**Temporary Holiday Camp, Place of Recreation, Sports or Culture, Barbecue Site
and Eating Place with Ancillary Facilities and Associated Filling of Land and Pond
for a Period of 3 Years in "Agriculture" Zone,
Various Lots in D.D. 107 and D.D. 109, Fung Kat Heung, Kam Tin, Yuen Long, New Territories**

(S.16 Planning Application No. A/YL-KTN/1253)

Responses on DSD's Requirements and Reminders

Response to Comment Table Based on Comments in
22 September 2026

LAYOUT PLAN FOR RUNOFF ESTIMATION FOR PROPOSED DRAINAGE WORKS

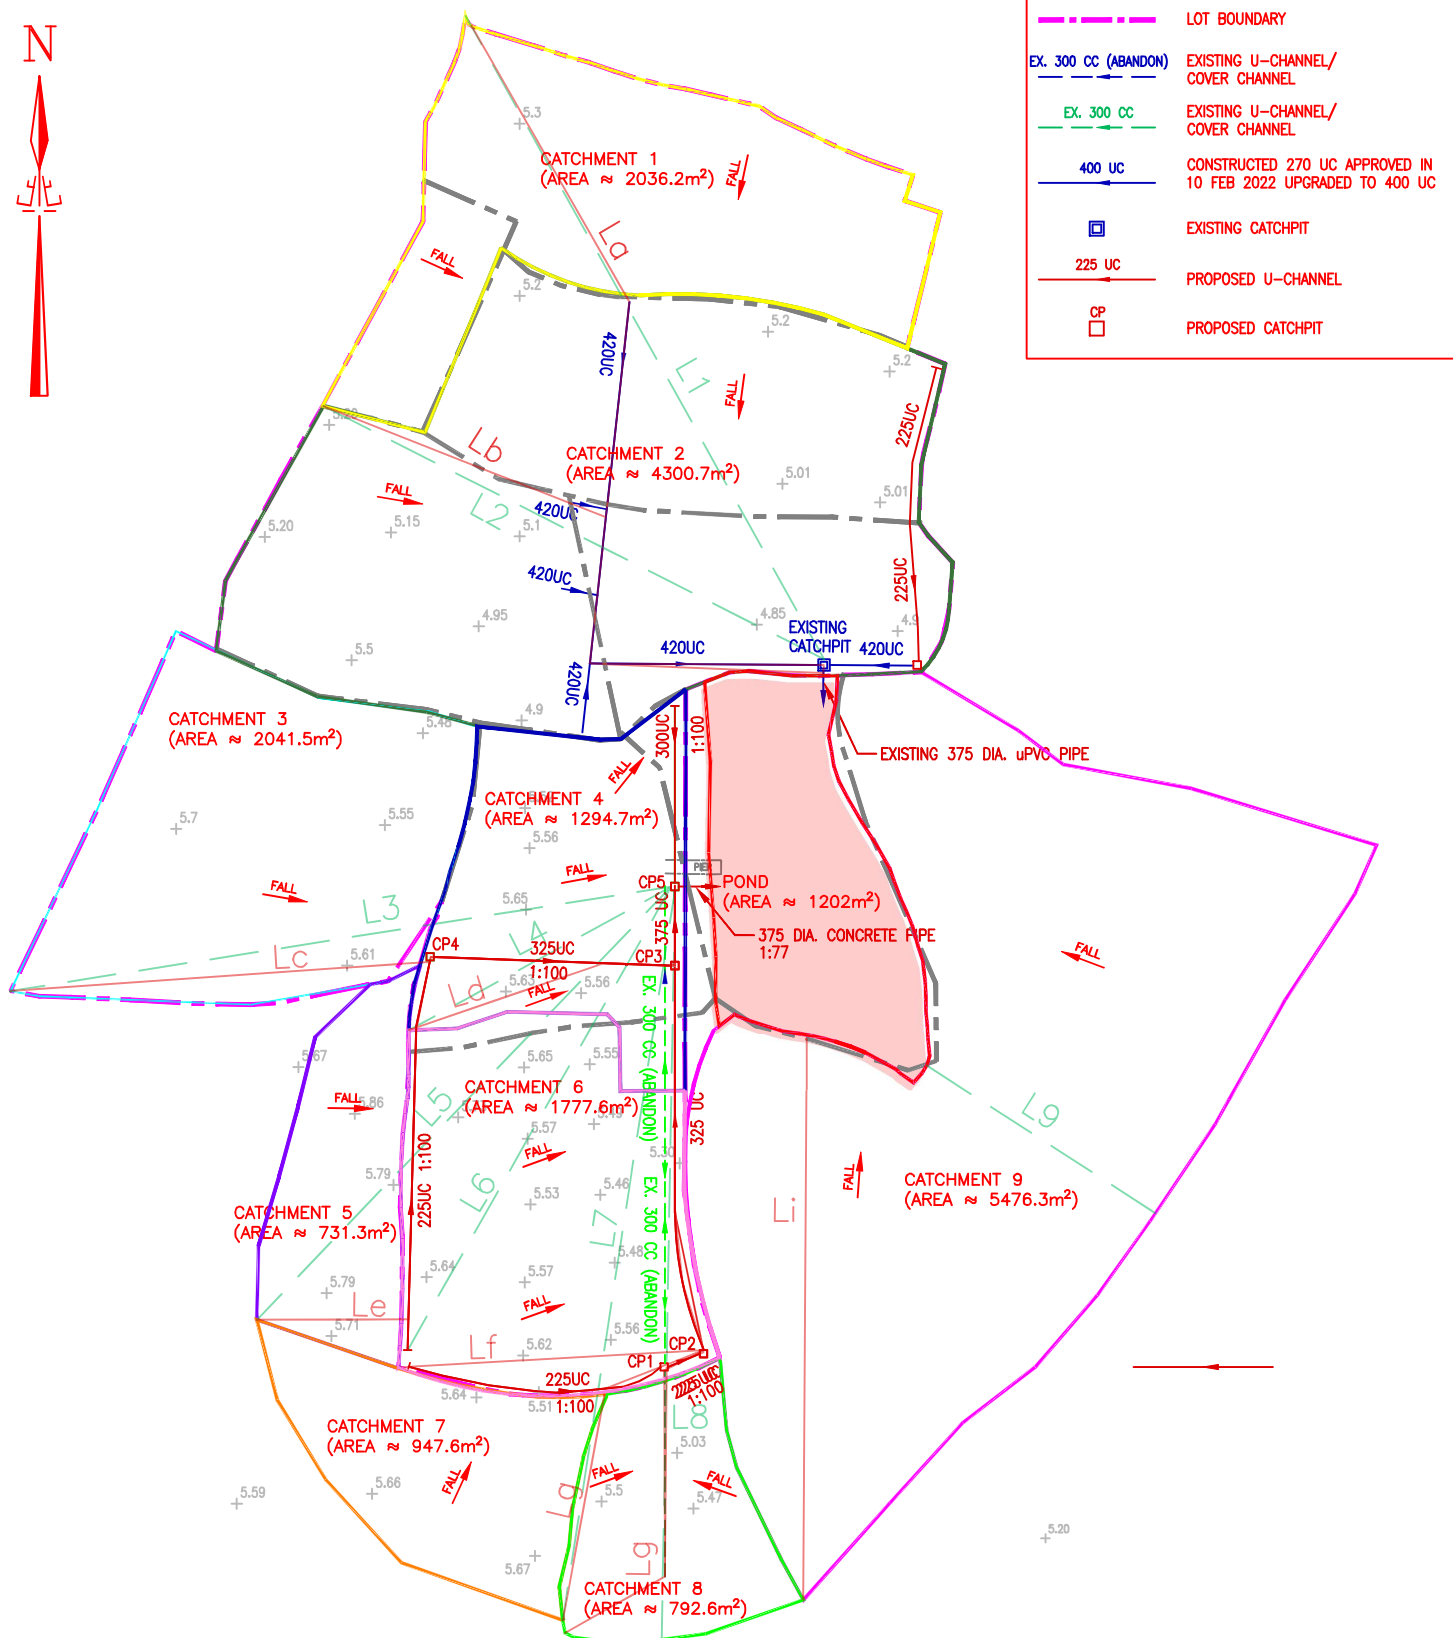
(g) Please demonstrate the adopted distance (on plan) measured on the line of natural flow between the summit and the point under consideration for the calculation of time of concentration.	Noted. The distance applied in the calculation of time of concentration is show on the layout plan for runoff estimation in Appendix G & H .

FIGURE 2

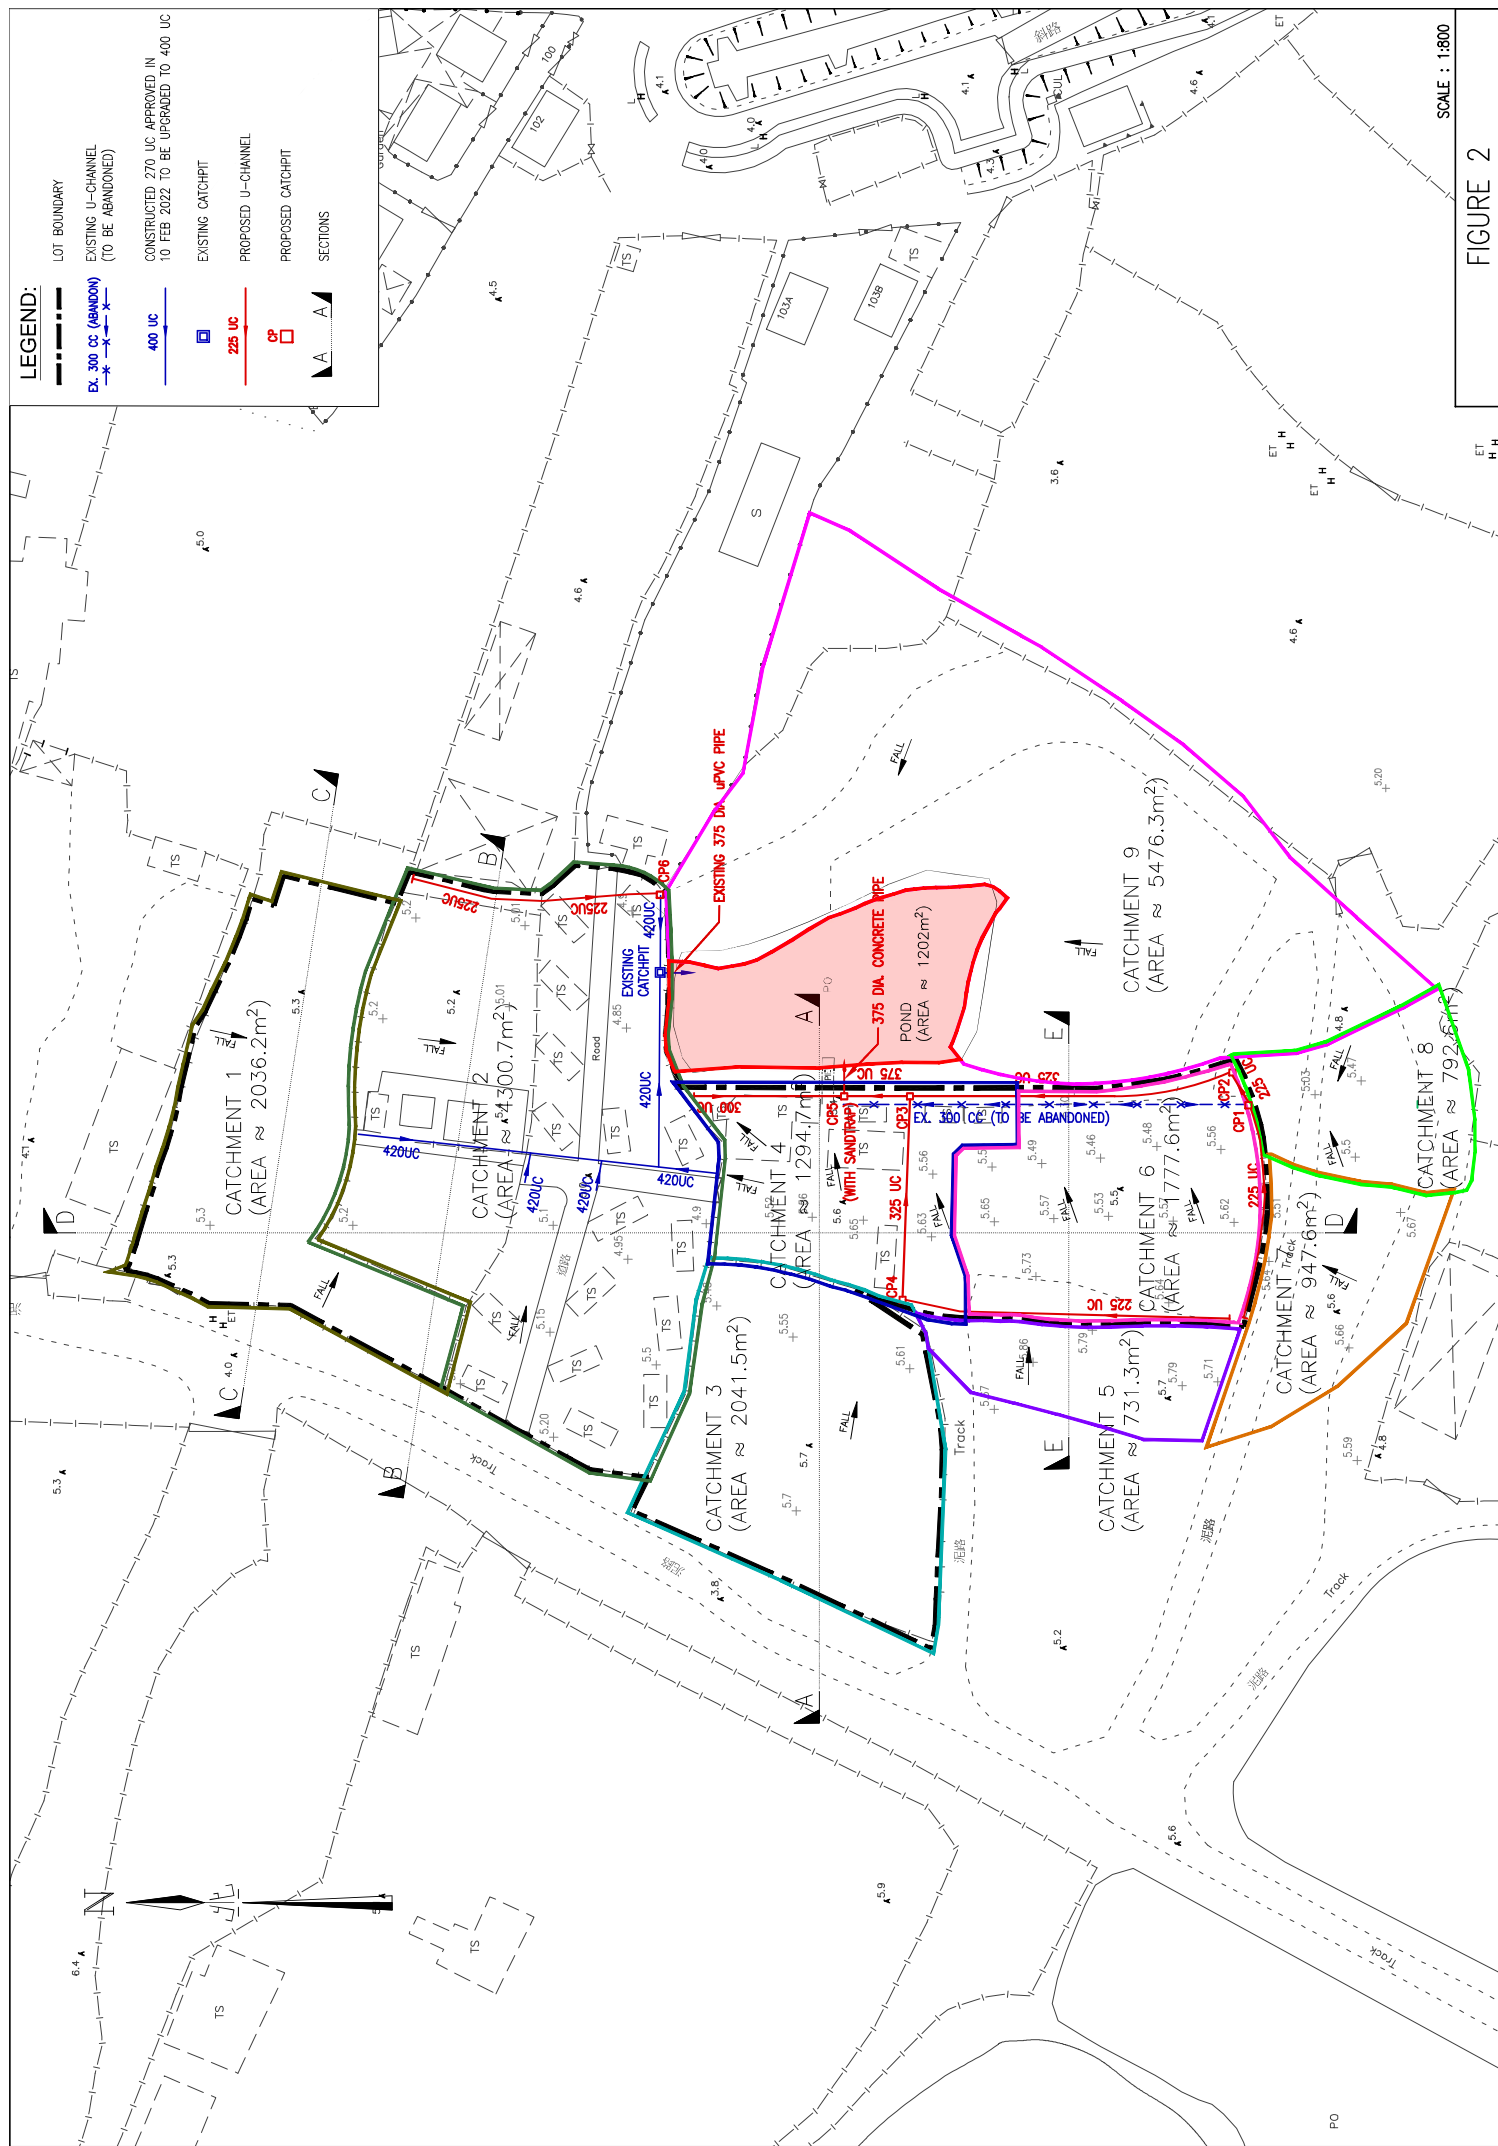
DSD/LD Comment	Response to DSD/LD Comments
(a) Please clarify the discrepancy of the pond area mentioned in September 2025 Report in Appendix F (1202m ²) and Figure 2 in Appendix H (1084.4m ²).	(a) Noted. The pond area is revised to 1202m ² in Figure 2 and related calculation.

FIGURE 3

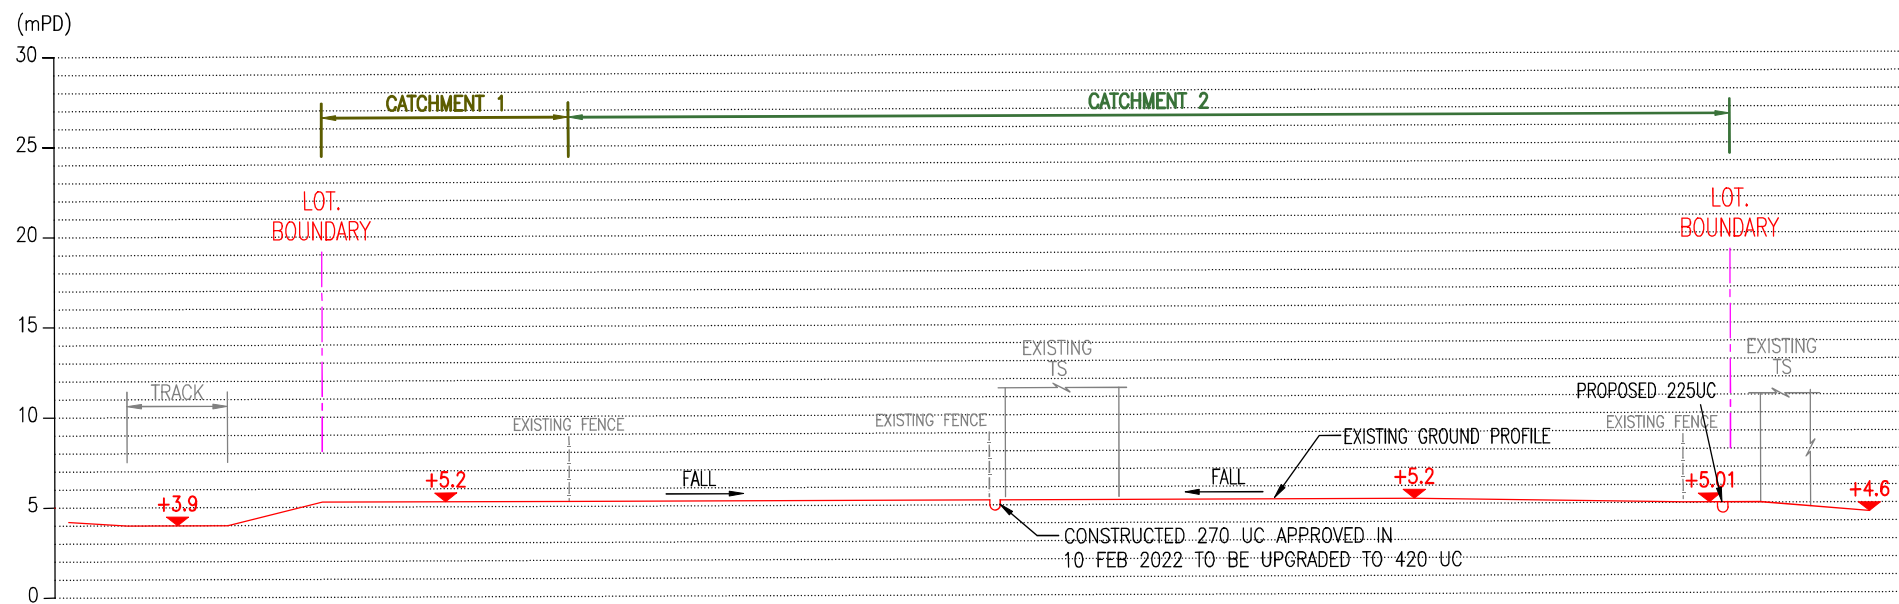
(c) Please review if “Existing 400 UC” as shown on Section B-B in Figure 4 should read “Proposed 400UC”.	Noted. “Existing 400UC” is revised to “CONSTRUCTED 270 UC APPROVED IN 10 FEB 2022 TO BE UPGRADED TO 420 UC”

(d) As shown on Section B-B, the existing ground level is higher than the area at the right. Please provide peripheral surface channel to collect the surface runoff accrued on the application site.	Noted. A 225mm peripheral channel is proposed at east of Catchment B to collect the surface runoff

CATCHPIT WITH TRAP

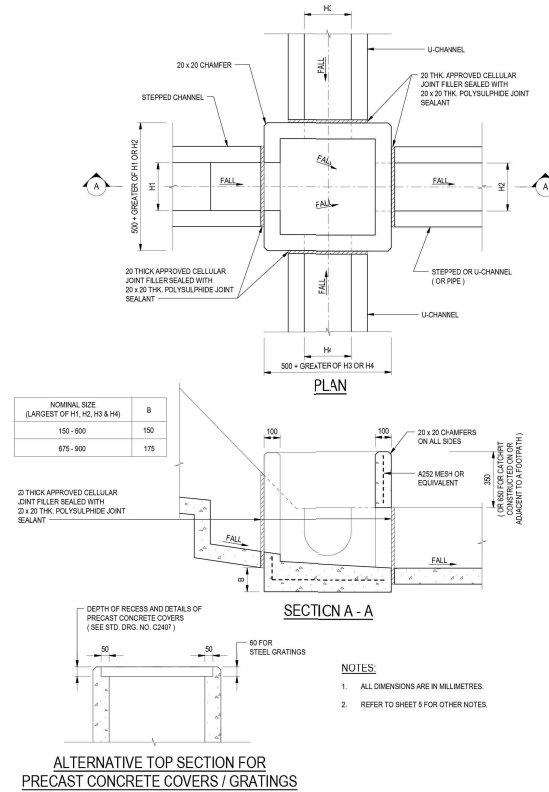
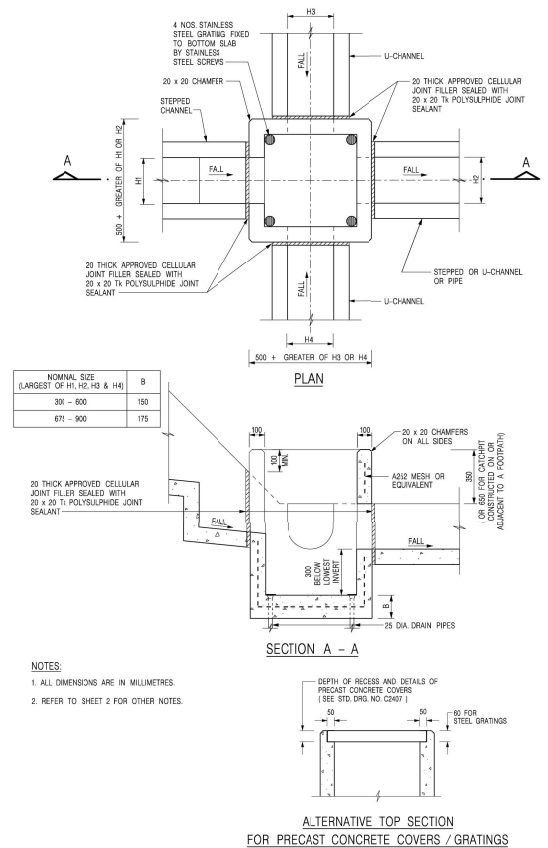
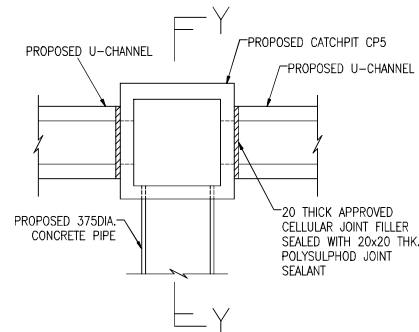
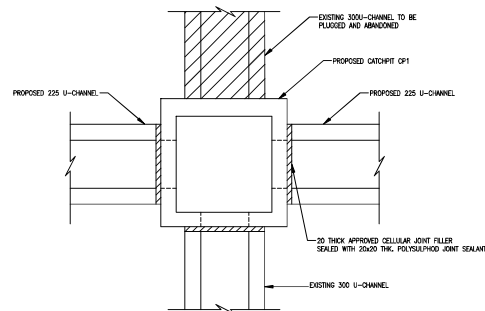
(f) Please provide the connection details at the discharge point and indicate details (e.g. cover level, invert level and watercourse bottom level) in the drawing.	Noted. The connection detail is provide in Fig. 8 for reference.

(m) The details of catchpit with sand trap or provision alike was indicated on Figure 8 in Appendix H. However, the feature of catchpit with sand trap was not clearly indicated on plan and legend. Please review.	Noted. The catchpit with sandtrap (CP5) is indicated on plan and catchpit schedule.
